2.0 SAFETY LIMITS

LIMITING SAFETY SYSTEM SETTINGS

DESCRIPTION: Ltr trans the following...change to tech specs...	ENCLOSURES: Proposed change to tech specs, notarized 2-27-74....
DO NOT REMOVE	
(40 cys encl rec'd)	
PLANT NAME: Monticello

FIGURE 2.1.1 FUEL CLADDING INTEGRITY SAFETY LIMIT

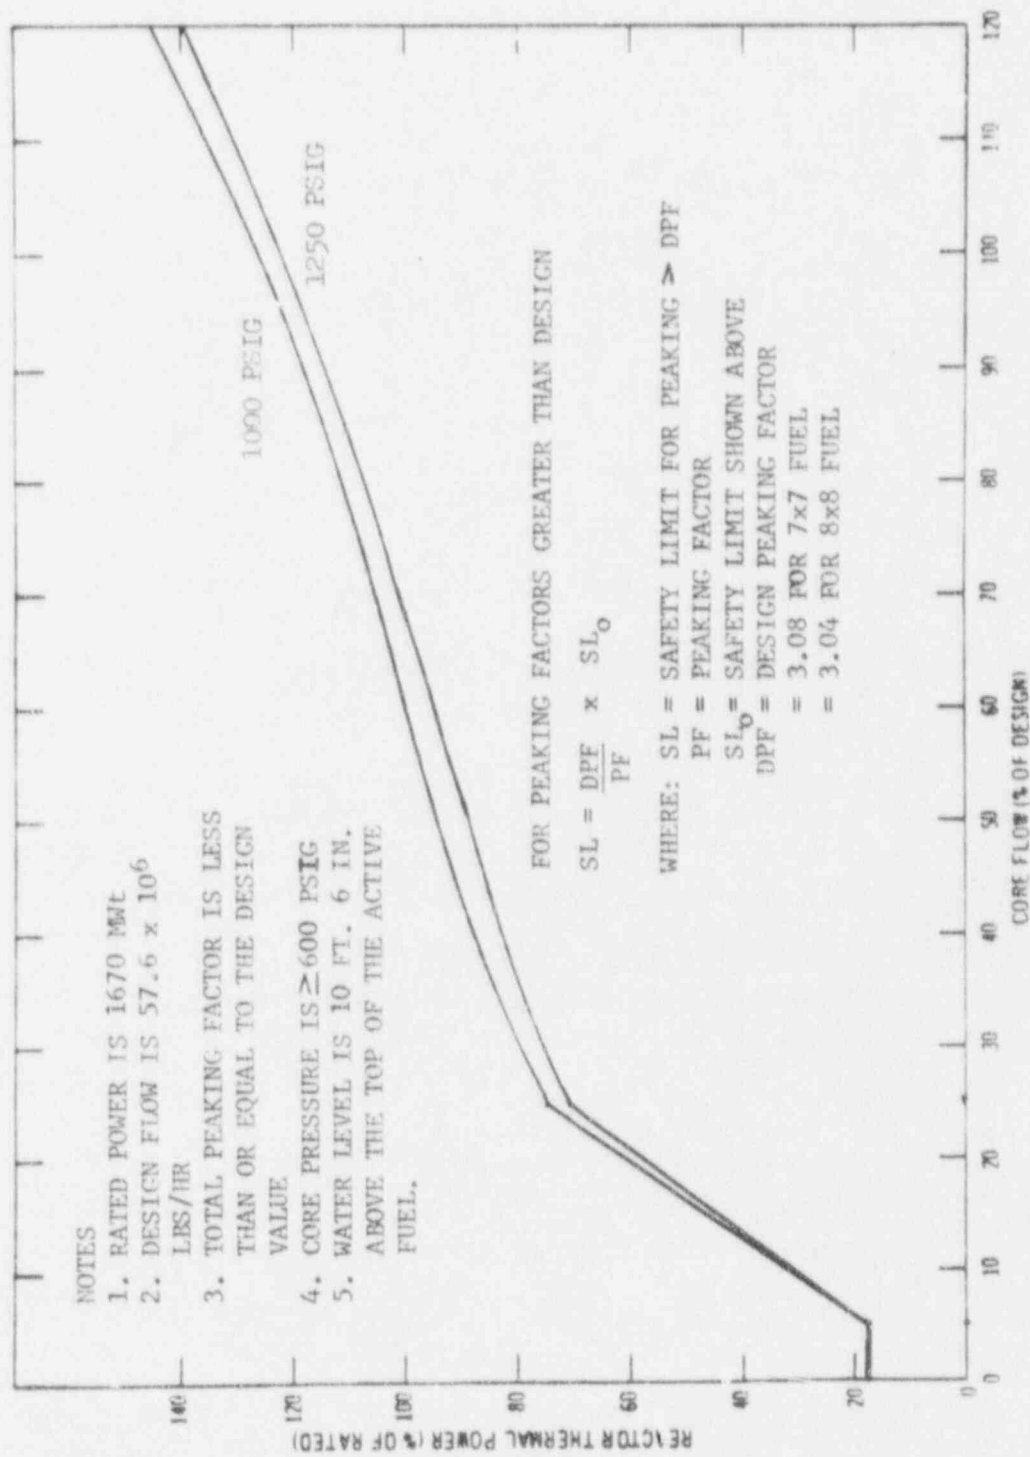
- A. When the reactor pressure is greater than 600 psig, the combination of reactor coolant core flow and reactor thermal power transferred to the coolant shall not exceed the limit shown in Figure 2.1.1. The safety limit is exceeded when the reactor coolant core flow and thermal power transferred to the coolant results in a point above or to the left of the limit line.

Curves are presented for two different pressures in Figure 2.1.1. The upper curve is based on a normal operating pressure of 1000 psig. The lower curve is based on a pressure of 1250 psig. In no case is reactor pressure ever expected to exceed 1250 psig, and therefore, the curves will cover all operating conditions with interpolation. If reactor pressure should ever exceed 1250 psig during power operation, it would be assumed that the safety limit has been violated. For pressures between 600 psig, which is the lowest pressure used in the critical heat flux data, and 1000 psig, the upper curve is applicable with increased margin.

The power shape assumed in the calculation of these curves was based on design limits and results in a total peaking factor of 3.08 for 7x7 fuel and 3.04 for 8x8 fuel. For any peaking of smaller magnitude, the curves are conservative. The actual power distribution in the core is established by specified control rod sequences and is monitored continuously by the in-core Local Power Range Monitor (LPRM) System. To maintain applicability of the safety limit curve, the safety limit will be lowered according to the equation given in Figure 2.1.1 in the rare event of power operation with a total peaking factor in excess of the design value.

The thermal hydraulic safety limit of Specification 2.1 was based on a total peaking factor of 3.08 for 7x7 fuel and 3.04 for 8x8 fuel. A factor has been included on Figure 2.1.1 to adjust the safety limit in the event peaking factor exceeds the design value. Likewise, the scram setting should also be adjusted to assure MCHFR does not become less than 1.0 in this degraded situation. This has been accomplished by use of Figure 2.3.2. If the combination of power and heat flux is greater than shown by the curve; i.e., a peaking factor greater than the design value exists, the APRM scram setting is adjusted downward by the formula given in the specification. The scram setting as given by the equation will prevent MCHFR from becoming less than 1.0 for the given heat flux condition for the worst expected transients. If the APRM scram setting should require a change due to an abnormal peaking condition, it will be done by increasing the APRM gain and thus reducing the slope and intercept point of the flow - biased scram curve by the reciprocal of the APRM gain change.
